2.0 SITE CHARACTERISTICS

This chapter of the North Anna 3 Combined License (COL) Final Safety Analysis Report (FSAR) addresses the geological, seismological, hydrological, and meteorological characteristics of the site and vicinity, in conjunction with present and projected population distributions and land use and site activities and controls.

The site characteristics are reviewed by the U.S. Nuclear Regulatory Commission (NRC) staff to determine whether the applicant has accurately described the site characteristics and site parameters together with site-related design parameters and design characteristics in accordance with Title 10 of the *Code of Federal Regulations* (10 CFR) Part 52, "Licenses, certifications, and approvals for nuclear power plants." The review is focused on the site characteristics and site-related design characteristics needed to enable the staff to reach a safety conclusion on the siting of North Anna 3. The North Anna 3 combined license application (COLA) references the Economic Simplified Boiling-Water Reactor (ESBWR) Design Control Document (DCD) as well as the North Anna 3 early site permit (ESP-003). For a COL application referencing a design certif

Figure 2.4.2-1. Site map with locations of drainage basins and primary hydraulic features of the drainage system flooding analysis from local intense precipitation (after North Anna 3 COL FSAR Figure 2.4-201)

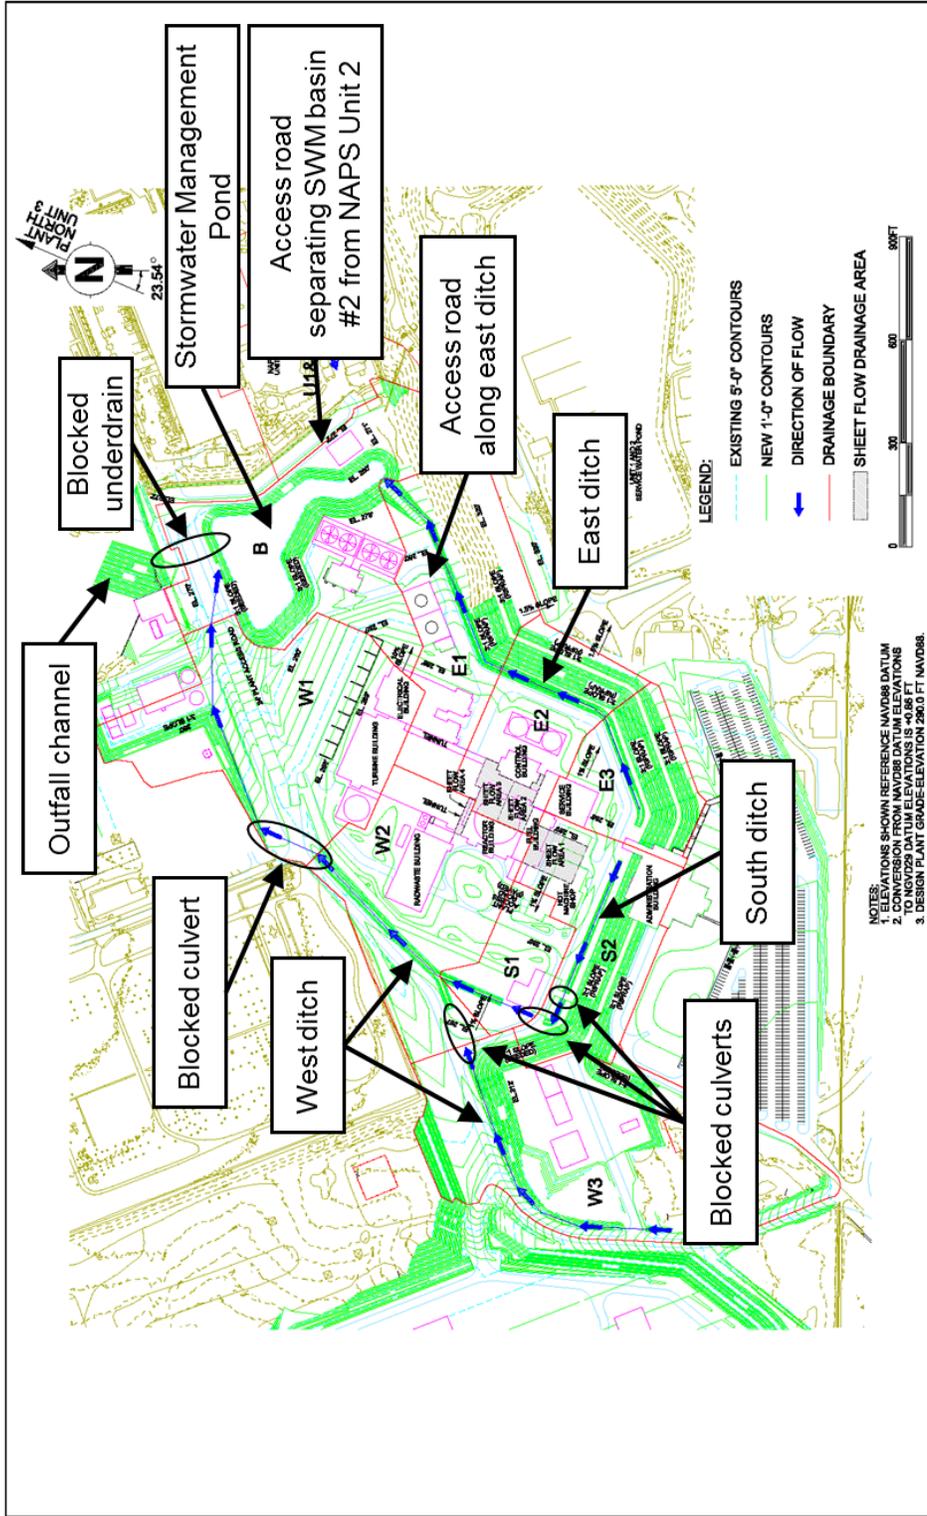
The site drainage plan consists of three drainage channels (labeled east ditch, south ditch, and west ditch in Figure 2.4.2-1), a stormwater management pond, and an outfall channel. Figure 2.4.2-1 also shows the layout of drainage basins used in the estimation of local intense precipitation-generated runoff. For the analysis of local intense precipitation flooding, the culverts were assumed to be blocked where the ditches passed under the plant access roads. In the HEC-RAS model of the drainage system, the roads crossing the ditches were treated as broad-crested weirs. As noted in Figure 2.4.2-1, these weirs are located in the south and west ditches. The east ditch has no weirs. Figure 2.4.2-2 shows the layout of HEC-RAS cross sections with respect to the ditches, stormwater management pond, and outfall channel. Figure 2.4.2-2 also shows the locations of blocked culverts, which were simulated as inline weirs.

According to North Anna 3 COL FSAR Revision 8, Figures 2.4-201 and 2.4-203, the discharge from the west ditch was combined with the outflow from the stormwater management pond. However, according to the geometry of the HEC-RAS model provided by the COL applicant, the staff discovered that the discharge from the west ditch entered the stormwater management pond. Therefore, in RAI 02.04.02-12, the staff requested that the COL applicant provide an explanation for the disagreement between the North Anna 3 COL FSAR figures and the HEC-RAS input files and any necessary corrections. The COL applicant's response dated January 19, 2015 (ADAMS Accession No. ML15022A199), and the staff's evaluation are described in the staff's technical evaluation section below in this SER.

The staff noted that the applicant's HEC-RAS input file geometry was inconsistent with the connectivity of the west ditch for the storm water management pond. In RAI 02.04.02-12, the staff requested that the COL applicant explain the apparent disagreement between the HEC-RAS input files and North Anna 3 COL FSAR Figures 2.4.201 and 2.4.203 which illustrate the connection of the west ditch to the stormwater management pond. In response to RAI 02.04.02-12 (ADAMS Accession No. ML15022A199), the COL applicant stated that as the west ditch approaches the stormwater management pond, water will flow in three directions: a portion will flow north into an area adjacent to the intake channel, another portion will flow south into the stormwater management pond, and a third portion will continue flowing along the west ditch towards the stormwater management pond outlet and into Lake Anna. The COL applicant chose to direct all flow from the west ditch into the stormwater management pond because the calculated water surface elevation would then be conservatively higher in Subbasin B. The COL applicant proposed updating North Anna 3 COL FSAR Figures 2.4-201 and 2.4-203 to correctly depict the discharge from the west ditch into the stormwater management pond, consistent with the HEC-RAS model setup. The staff determined that the COL applicant's response was adequate. The staff is tracking the COL applicant-proposed updates to North Anna 3 COL FSAR Figures 2.4-201 and 2.4-203 in a Confirmatory Item **[Confirmatory Item 2.4.2-3]**.

Figure 2.4.2-2. Site map with locations of the inline control structures that correspond to blocked culverts (after North Anna 3 COL FSAR Figure 2.4-203)

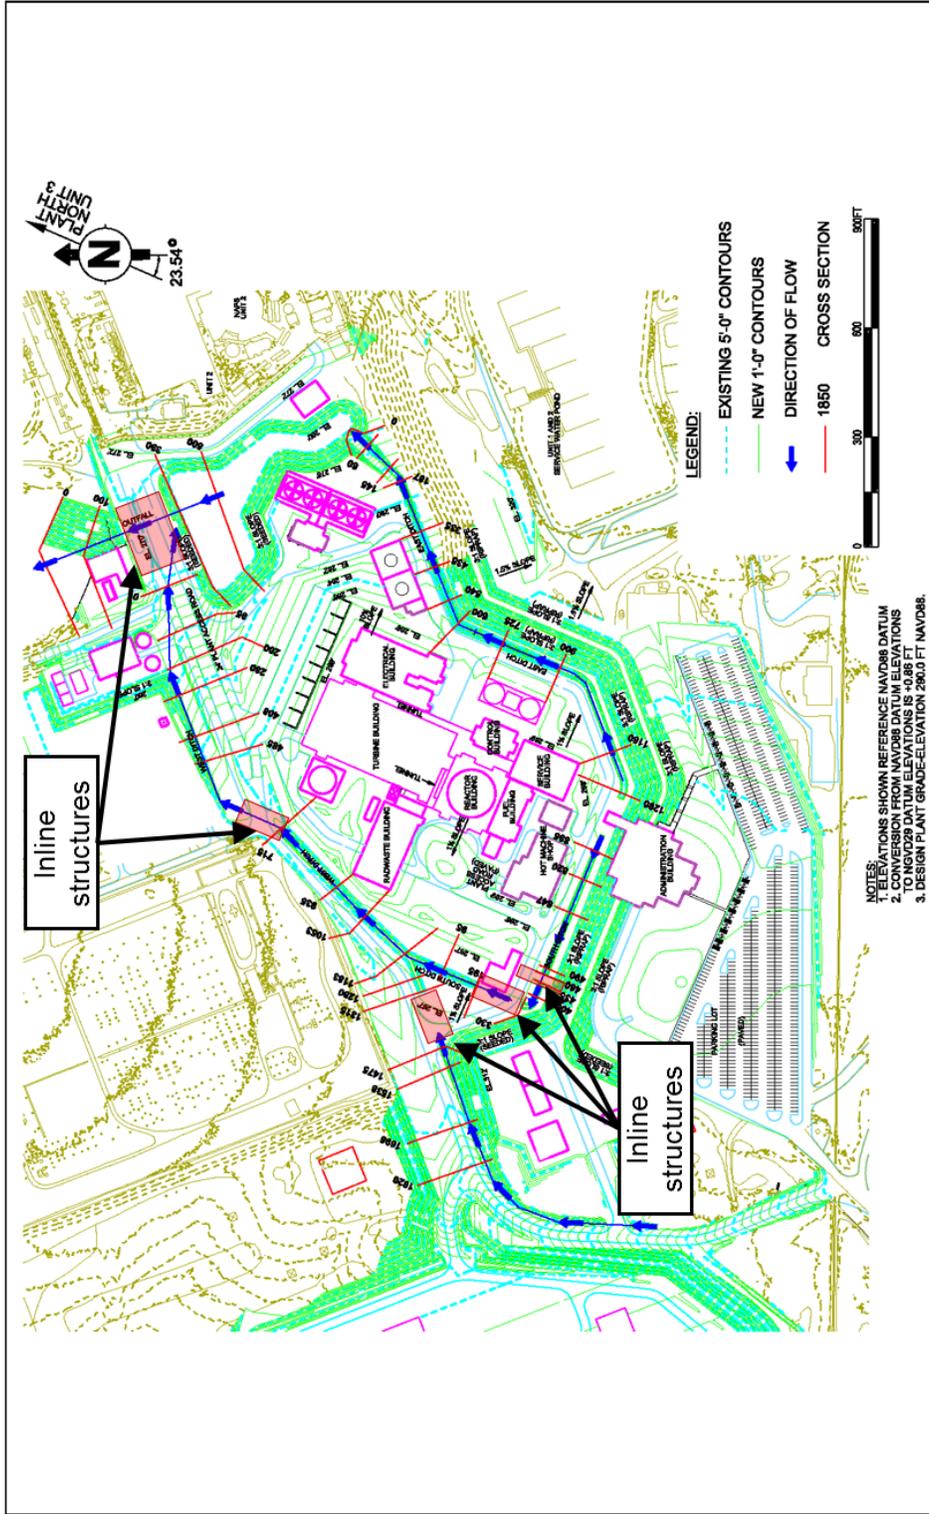
The COL applicant assumed that the roads crossing the west and south ditches and the outfall from the stormwater management pond were completely blocked and functioned as weirs during the flooding from local intense precipitation (Figures 2.4.2-1 and 2.4.2-2). As found in the COL applicant's HEC-RAS input files, inline weirs were designated as broad-crested weirs with discharge coefficients specified as either 2.6 or 2.4. Because the COL applicant did not provide a justification for choosing the lower of these two discharge coefficient values, in RAI 02.04.02-14, the staff requested that the COL applicant provide a discussion of the basis for selecting weir discharge coefficients. The COL applicant's response dated January 19, 2015 (ADAMS Accession No. ML15022A199), and the staff's evaluation are described in the staff's technical evaluation section below in this SER.

Figure 2.4.2-3. Site map with locations of supercritical flow and of hydraulic jumps from the applicant's HEC-RAS model and North Anna 3 COL FSAR Figure 2.4-221 (after North Anna 3 COL FSAR Figure 2.4-203)

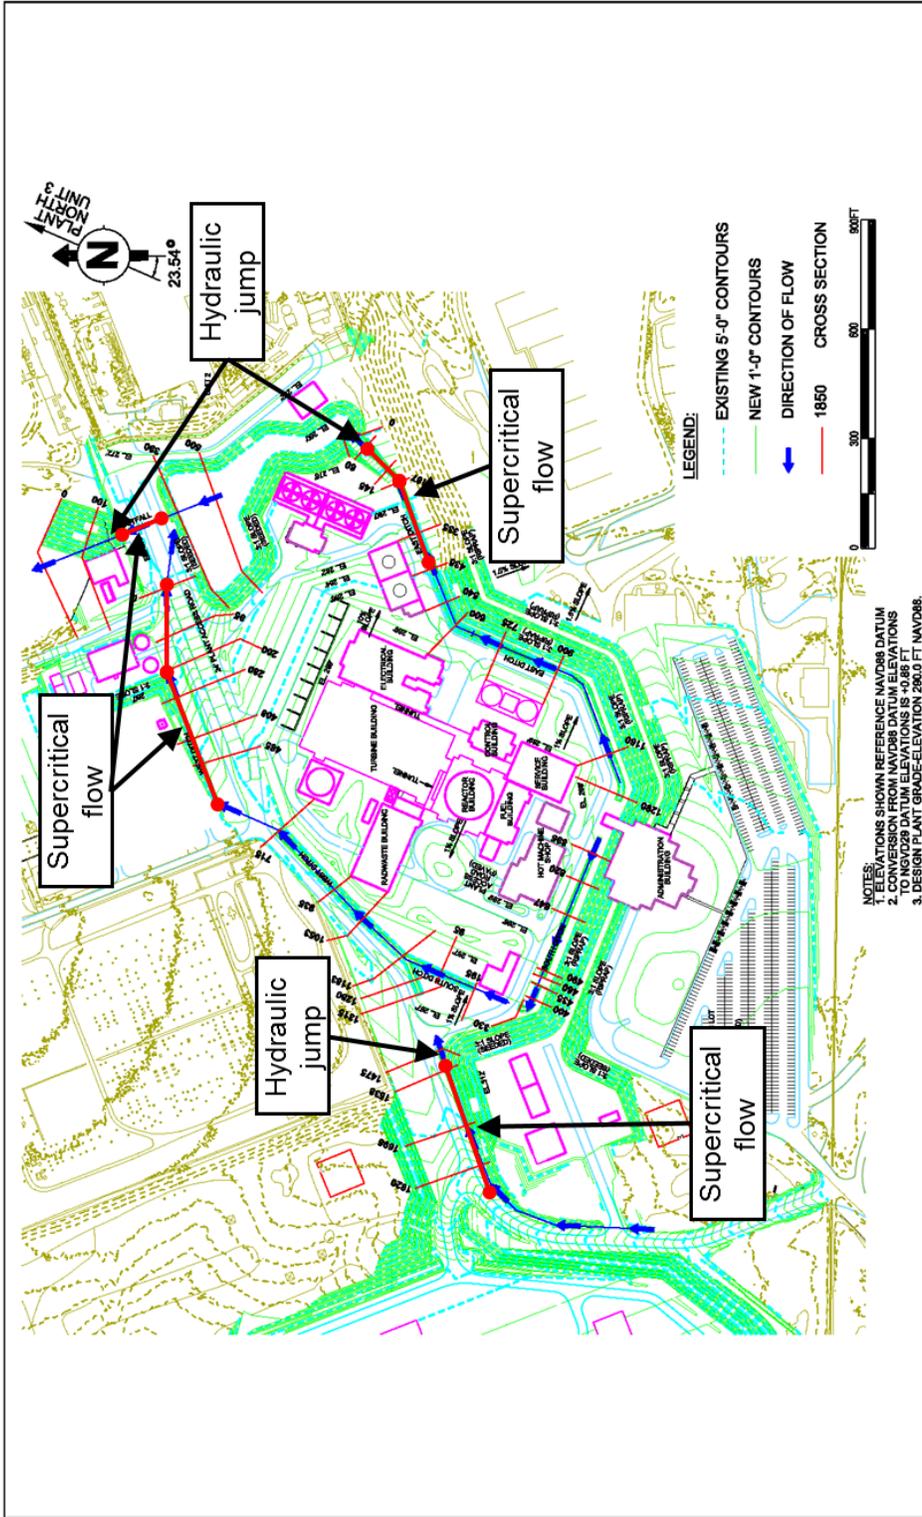
Based on the staff's examination of the COL applicant's HEC-RAS analysis results, supercritical flow was found to occur in the east and west ditches during flooding from local intense precipitation. In these locations, the water velocities ranged from 2.1 m/s (7.0 fps) to 4.5 m/s (14.7 fps) with Figure 2.4.2-3 showing the locations of supercritical flow based on the HEC-RAS analysis. In North Anna 3 COL FSAR Section 2.4.2.3, the COL applicant stated that:

- The locations where supercritical flow regimes were predicted to occur would be protected against possible erosive forces arising from large velocities and potential hydraulic jumps using linings and hardened surface protections;

Figure 2.4.12-1. NAPS Unit 3 groundwater head observations on 5/30/2007 as a function of ground surface elevation at the well

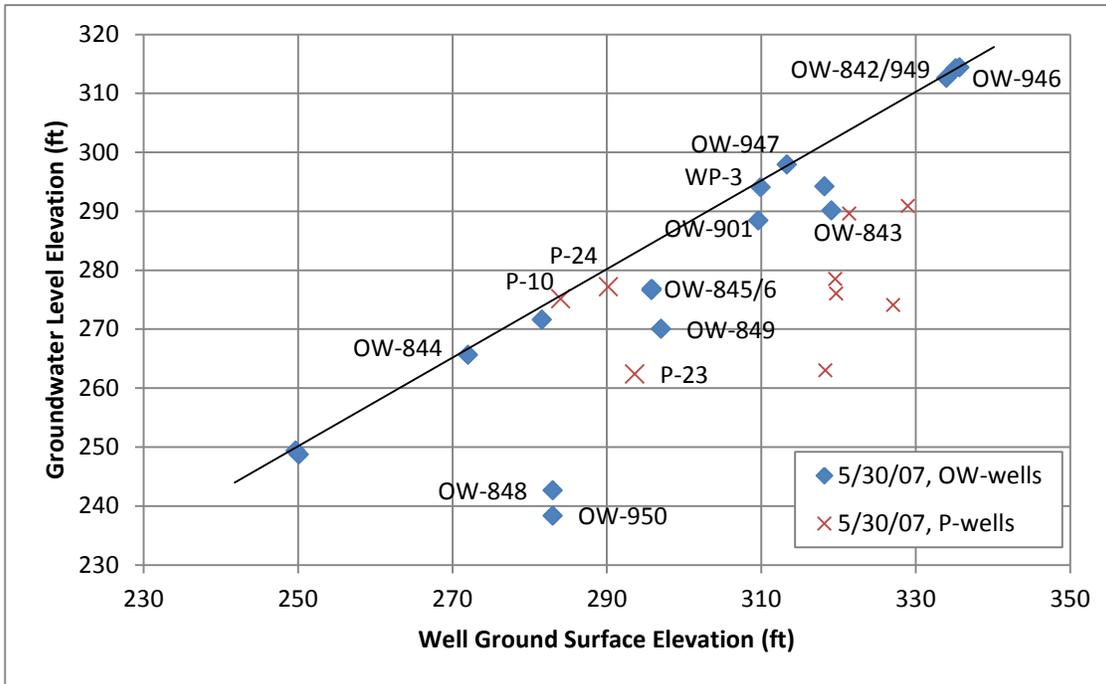
The COL applicant used groundwater head observations from May 30, 2007 to develop and evaluate the pre-construction groundwater model. The staff plotted these observations as a function of the ground surface elevation at the observation well locations, as shown in Figure 2.4.12-1³. As described above, the observations from well pairs at different depths indicated that generally minor vertical gradients exist at the site. The groundwater heads in this shallow unconfined system were therefore interpreted as water table elevations. The staff determined that observed groundwater levels were related to ground surface topography; the envelope of maximum observed groundwater levels was well-represented as a linear function of the ground surface elevation (with a slope of 0.75), as shown in Figure 2.4.12-1. Based on this relationship, maximum observed groundwater levels were close to ground surface at lower elevations (e.g., at the Lake Anna elevation of 76.20 m [250 ft.] NAVD88), and progressively deeper as the ground surface elevation increased (e.g., maximum groundwater level was 6.10 m [20 ft.] deep at a ground surface elevation of 100.58 m [330 ft.] NAVD88).

While no observations fall significantly above the envelope line in Figure 2.4.12-1, a number of observations fall significantly below the line. The staff examined the current site topography, as shown on FSAR Figure 2.4-206, and determined that the wells with observations below the line in Figure 2.4.12-1 tended to be located above and near a significant topographic slope. For example, OW-848 and OW-950 are on the bluff above the proposed North Anna 3 intake bay, and OW-849 and OW-843 are above the cut-slope for the switch yard. In contrast, the observations that lie close to the line in Figure 2.4.12-1 tended to be in areas of relatively flat topography, or near the bottom of topographic slopes. For example, OW-844 lies just below the cut-slope down to the Unit 1/2 operations level.

Figure 2.5.1-5. LiDAR-Derived Relief Map of the 2011 Mineral, VA, Earthquake Vicinity (from FSAR Figure 2.5.1-212A, Rev 9). Relief is represented as elevation difference within 0.5 km. The margin of Ellisville Biotite Granodiorite based on Burton et al. (2014) and Dicken et al. (2005)

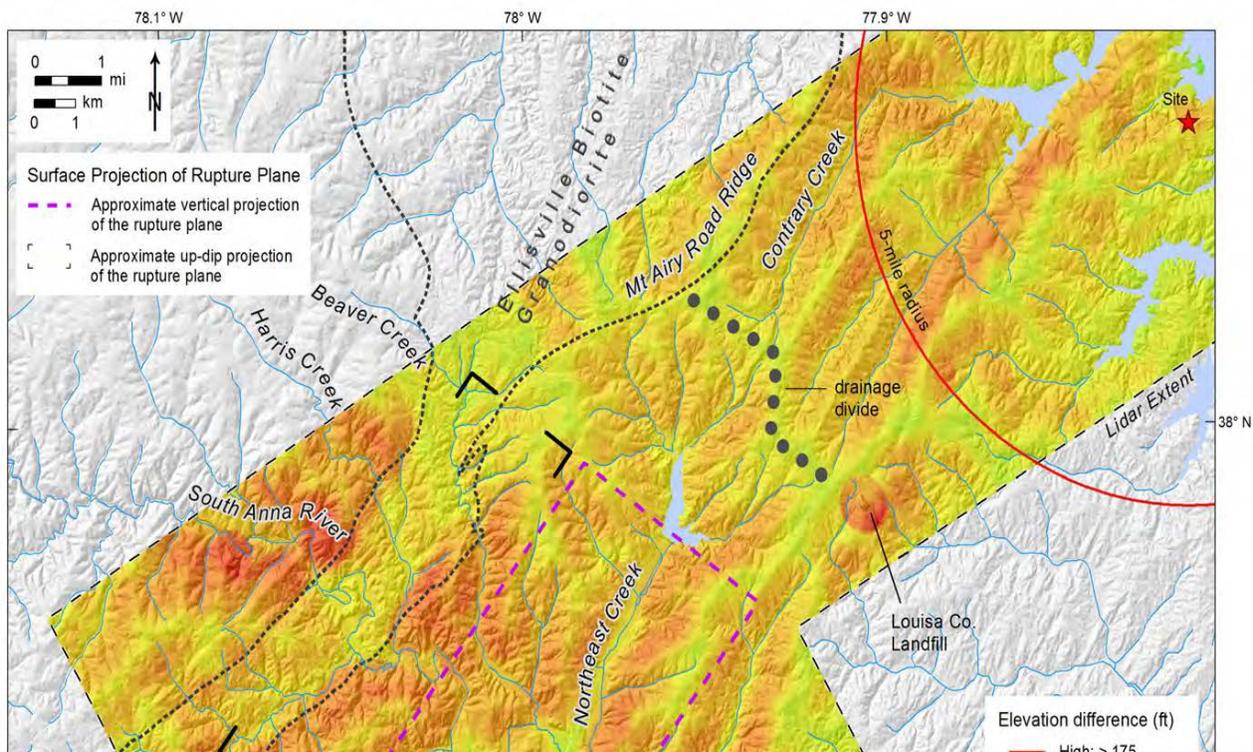
In response, the COL applicant provided new map figures to provide a basis for their analysis regarding surface deformation related to the Mineral earthquake. Figure 2.5.1-5 shows a newly derived relief map using a linear color ramp to symbolize the local relief value across the epicentral area and to the NE, closer to North Anna 3. The staff notes that, in the area around the Ellisville pluton neck, high to low relief boundaries closely correspond to geologic map unit contacts. This supports the COL applicant's suggestion that the steep relief gradients are related to lithologic difference between map units rather than subtle tectonic uplift related to shallow earthquakes. The Chopawamsic Formation, to the NW and SE of the Ellisville pluton neck, is more erosion resistant than the Ellisville and, therefore, supports higher elevation and higher relief zones. In addition, staff notes, that the South Anna river system crosses the same geologic contacts by the Ellisville neck and the Mineral earthquake epicentral area. The river is a significant erosional agent in the area and lowers elevations in its basin but also contributes to the development of high local relief within its basin (Compare Figures 2.5.1-5 and 2.5.1-6). The staff also notes that high relief values diminish to the NE, near the basin divide between the South Anna and the North Anna river systems. The most continuous areas of low relief can be found along prominent drainage divides and areas of higher elevation, which represent areas farthest removed from the increased erosion rates associated with trunk streams. The staff agrees with the COL applicant that the landscape revealed in the new relief and elevation maps supports the interpretation that erosion rates increase toward the trunk of major drainages, and this enhances differential erosion rates associated with variable lithology. Accordingly and in compliance with 10 CFR 100.23 and 10 CFR 52.79, the staff considers RAI 02.05.01-8a resolved and closed.

The COL applicant stated that the FSAR would be updated to reflect aspects of this response. The staff finds the proposed COL FSAR changes acceptable. RAI 02.05.01-8a is being tracked as a confirmatory item [**Confirmatory Item 2.5-04**] to ensure the proposed changes are incorporated into a future revision of the COL FSAR.

Figure 2.5.1-4. NAPS Geologic Field Reconnaissance after the 2011 Mineral, VA, earthquake showing traverse routes, waypoints and the LiDAR survey boundary (from FSAR Figure 2.5.1-204, Rev. 9)

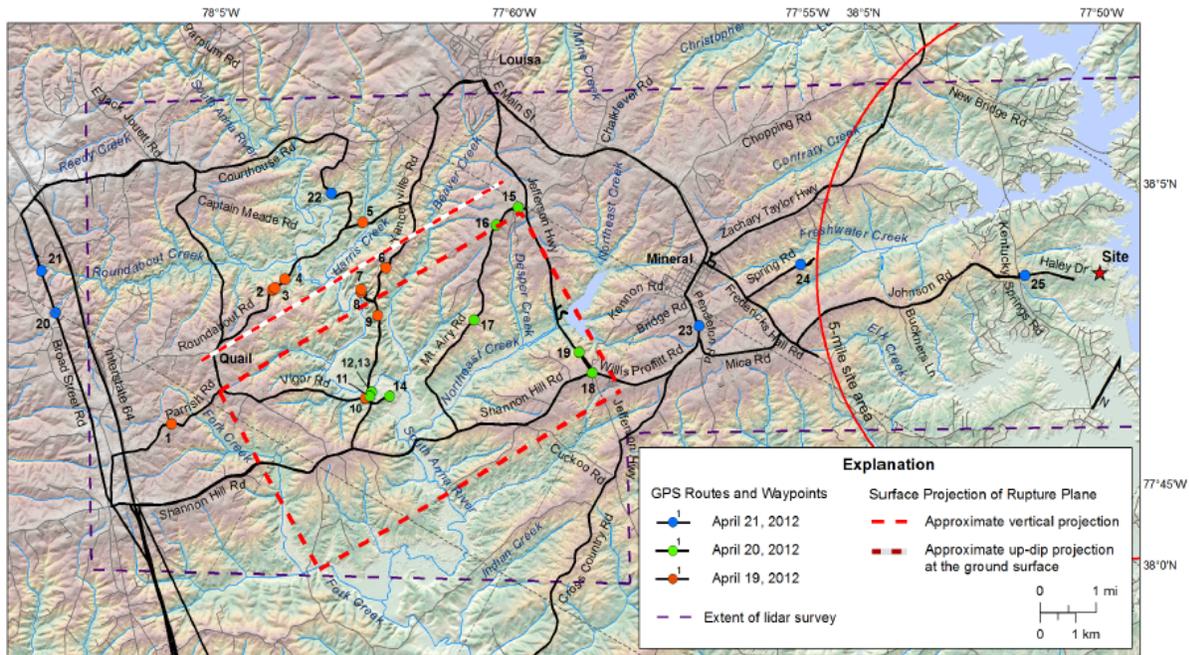
FSAR Section 2.5.1.1.7(b), Geologic Reconnaissance, provides information regarding the field reconnaissance program completed to evaluate potential surface deformation associated with the Mineral earthquake. The FSAR placed a special focus on the up dip projection of the Quail fault, evaluation of geomorphic features in the epicentral landscape, and a field map with routes and waypoints (Figure 2.5.1-4). The details of the field reconnaissance are reported in the Geologic Reconnaissance Report that staff audited on March 11, 2014. The summary of the staff's audit can be reviewed in (ADAMS Accession No. ML14203A211). The COL applicant provided a summary of the geologic reconnaissance program in FSAR Section 2.5.1.1.7b and c. The report addressed the question of whether the August 23, 2011, Mineral earthquake did or did not cause surface faulting or surface deformation. The report detailed geologic field reconnaissance and geomorphic analyses performed using high-resolution LiDAR elevation data in the region of the August 2011 M5.8 Mineral, Virginia, earthquake's epicentral region specifically acquired by Dominion for this field program. The report also included a compilation and evaluation of published information, communications with other researchers, all related to the potential for surface deformation in the site vicinity for North Anna Power Station North Anna 3. The staff issued an RAI relevant to the information found in this report. Thus in RAI 02.05.01-5 dated April 22, 2014 (ADAMS Accession No. ML14112A156), the staff asked the COL applicant to provide additional details about the data analysis and the field program including:

- a) At each waypoint, what was examined and what is its significance.
- b) Provide a high resolution LiDAR map (scale ~1: 10,000) for areas immediately west of North Anna 3 where fault 'a' might be located, such as waypoint sites 23, 24, and 25.
- c) Discuss longitudinal stream profile analysis completed in the epicentral area. Discuss any anomalies revealed by this analysis that could indicate subtle tectonic deformation in the hanging wall of the Quail fault, such as gradient changes, offset stream terraces, elevated topography.
- d) Explain how you evaluated the Quaternary geology of the epicentral area and the distribution, correlation and elevation of river terraces on the South Anna River. Discuss any indication of subtle surface uplift in river terraces on the hanging wall of Quail fault that might indicate prolonged or repeated surface deformation.

In a June 10, 2014, response to RAI 02.05.01-5a and b (ADAMS Accession No. ML14177A441), the COL applicant provided a table with details for the significance of each waypoint visited during the field reconnaissance program. Observations at some of the waypoints confirm structural, geomorphic features or relationships previously published by others or observed by Dominion. The staff notes in particular that Waypoint 25, located just outside the plant boundary, is along the extended strike of fault ‘a’, as mapped by Mixon et al. (2000). The waypoint is located on a flat, broad ridge crest, with a deeply weathered soil profile. This ridge crest is likely one of the more stable landforms in this area and useful to evaluate potential deformation or activity on fault ‘a’. The COL applicant provided several detailed LiDAR-based elevation panels of the waypoints they examined to evaluate the possible extent of fault ‘a’. The staff notes that there are no anomalous features revealed in the detailed LiDAR-based elevation panels to indicated surface faulting or deformation. The COL applicant pointed out that the lack of expression of fault ‘a’ in this area support previous studies that determined fault ‘a’ to be pre-Quaternary.
